ADDENDUM #2

BID# IB 03-23-24

Tree Replanting and Additional Irrigation Installation

SANTA CLARA COUNTY OFFICE OF EDUCATION

CLOCK "A"

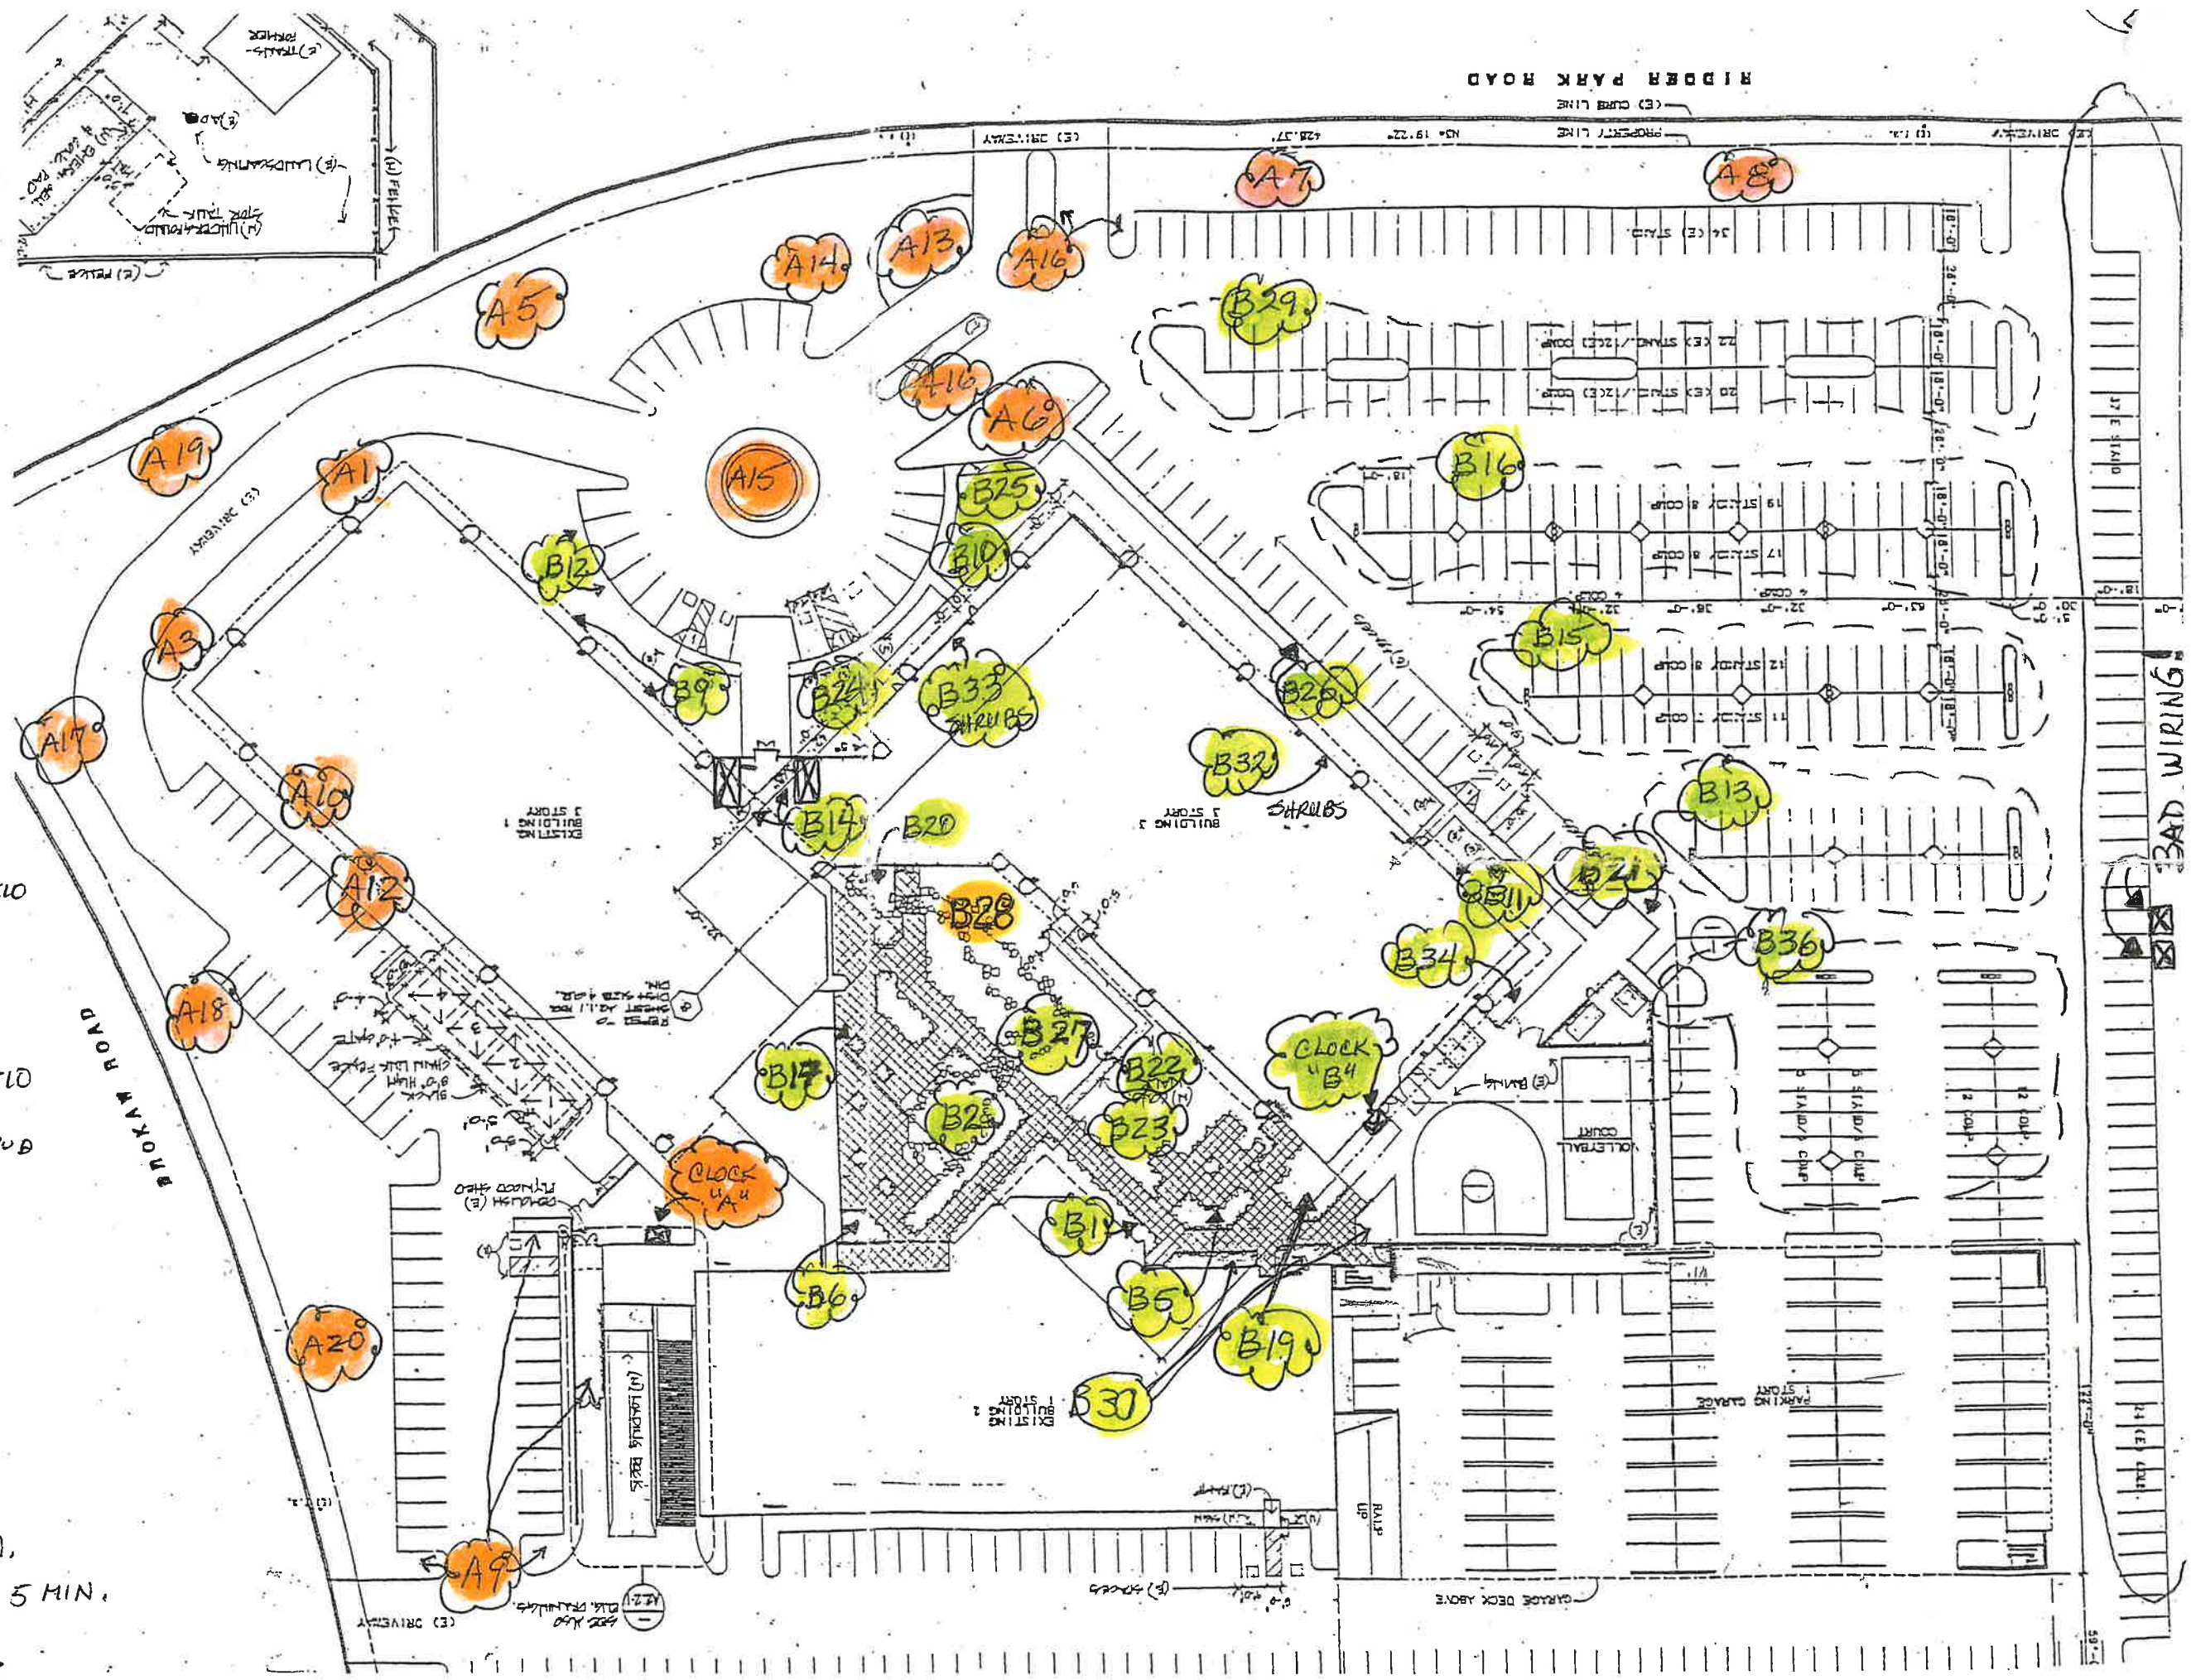
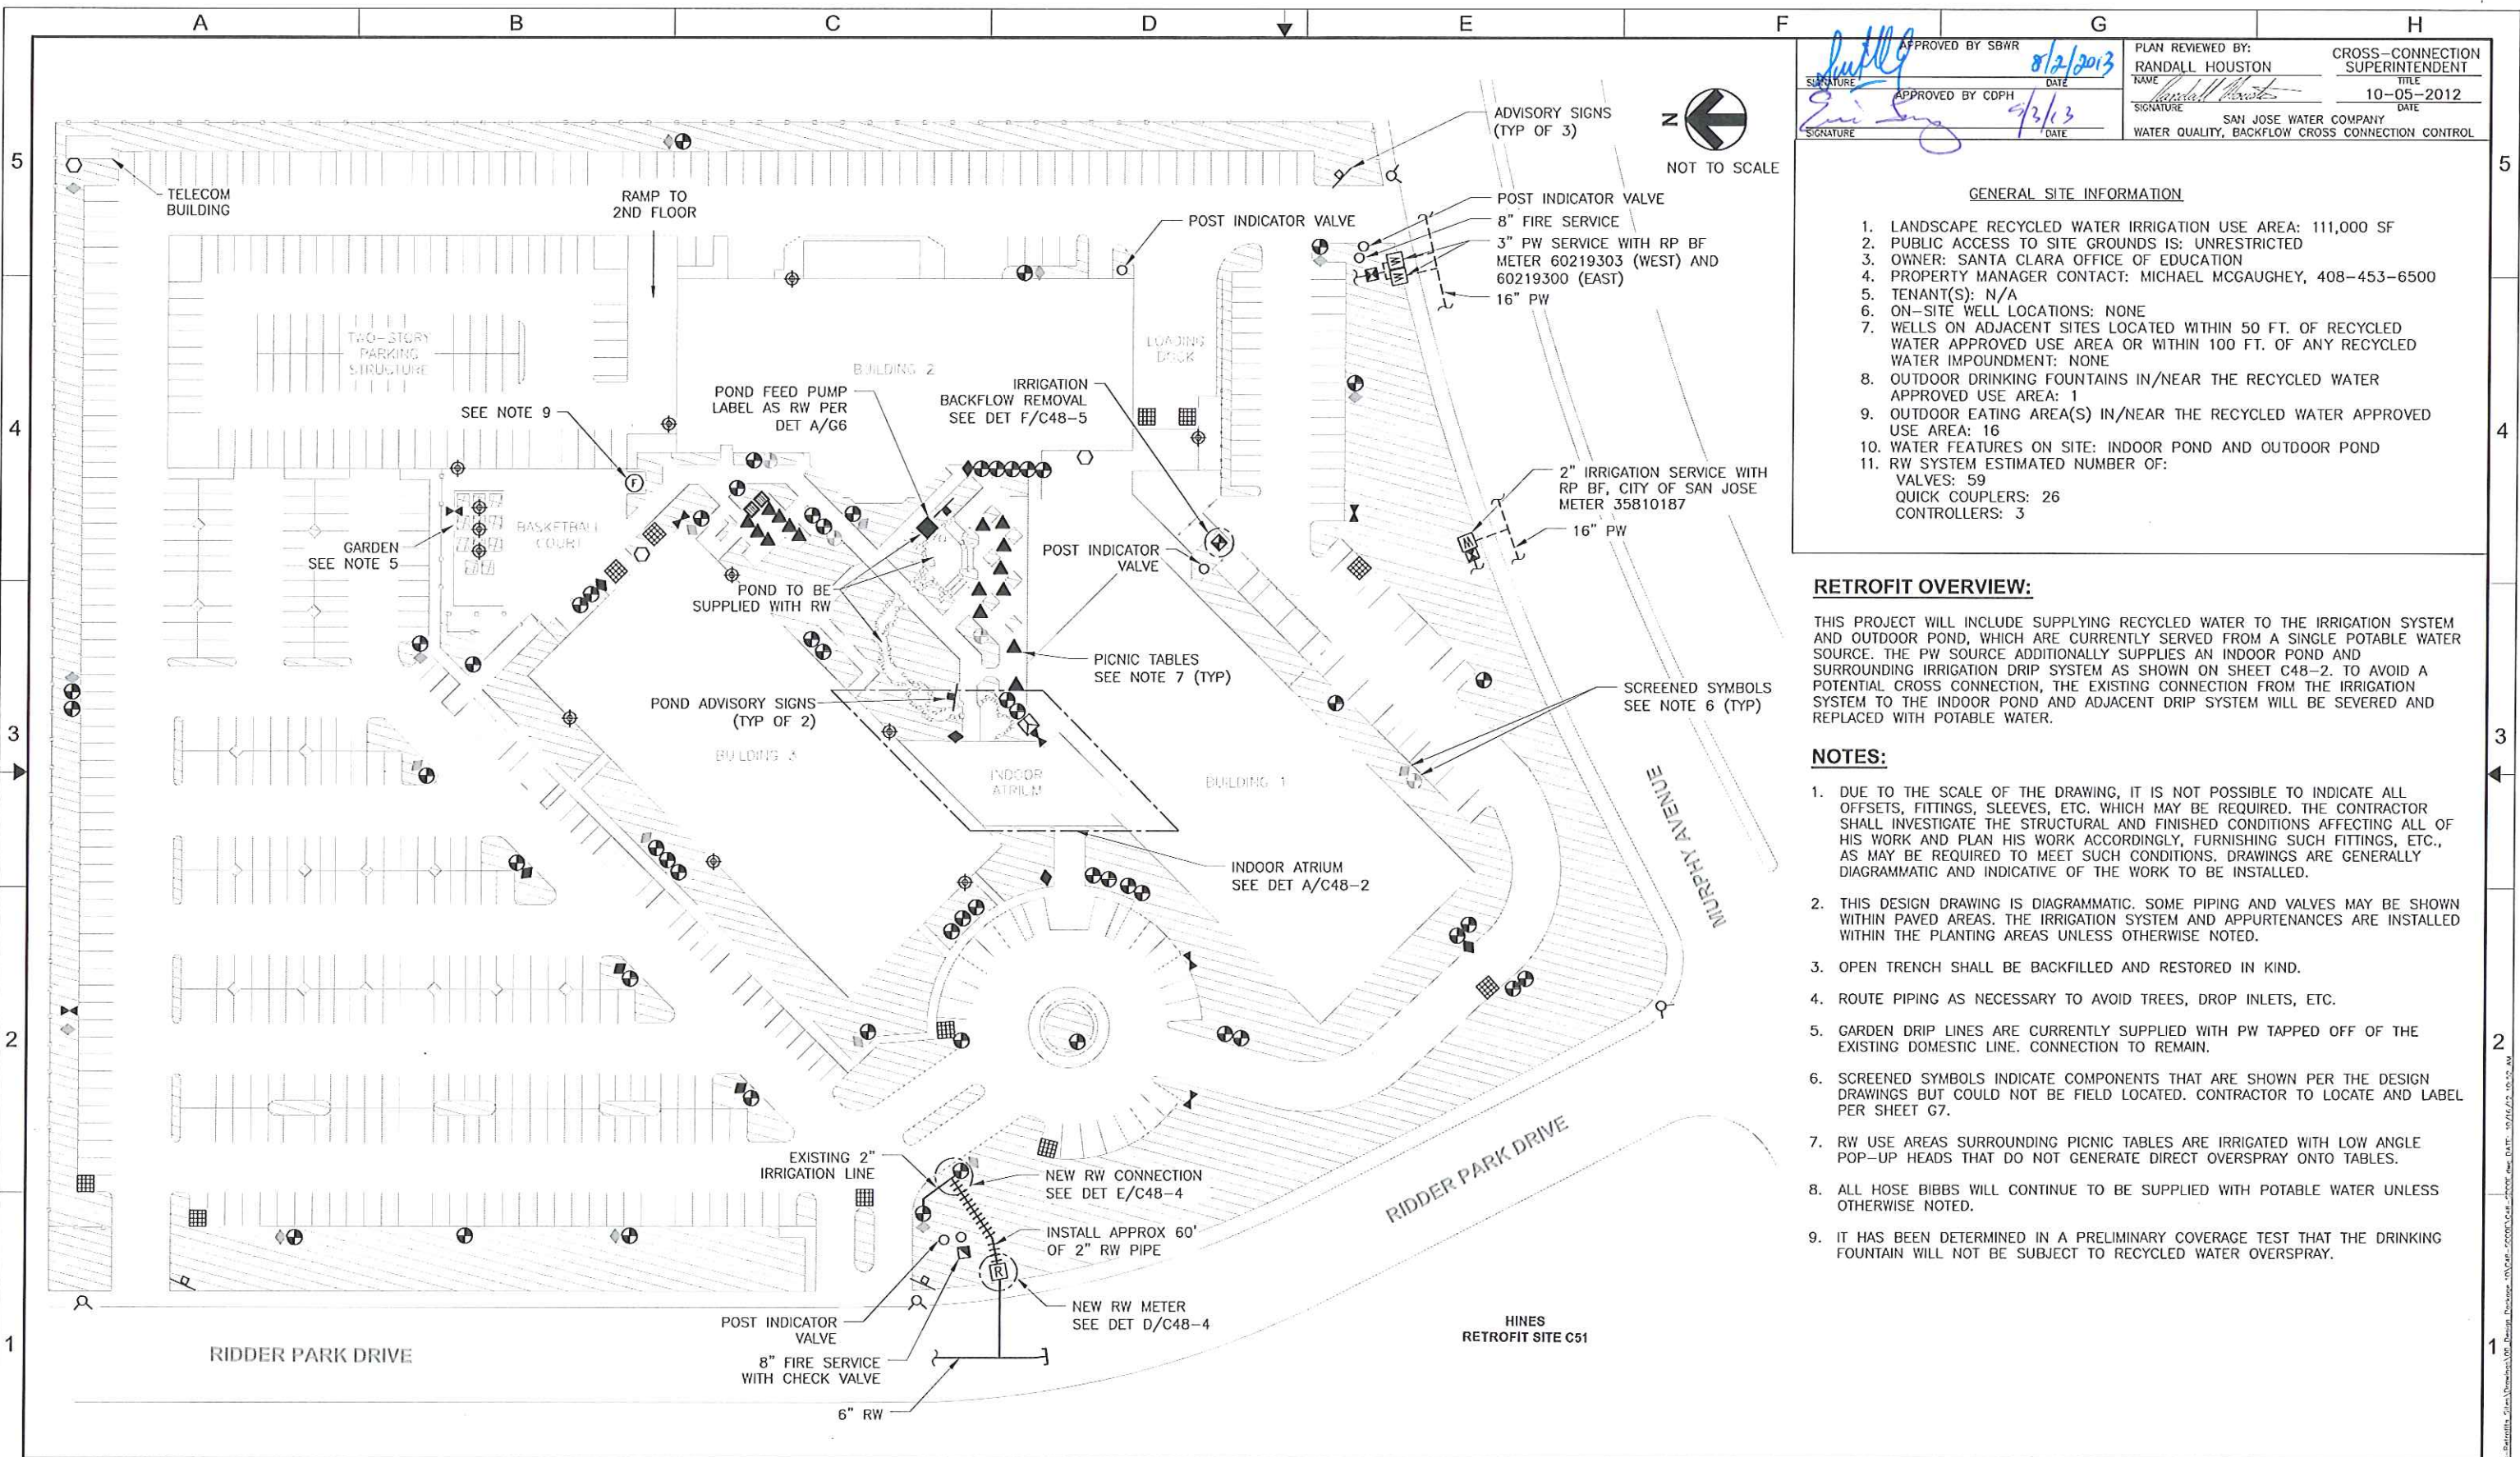
#1. Question: Is there Campus as built of the irrigation system as well as controller location?

Answer: Refer to Irrigation valve & Clock location plan Addendum 2 10.25.2023
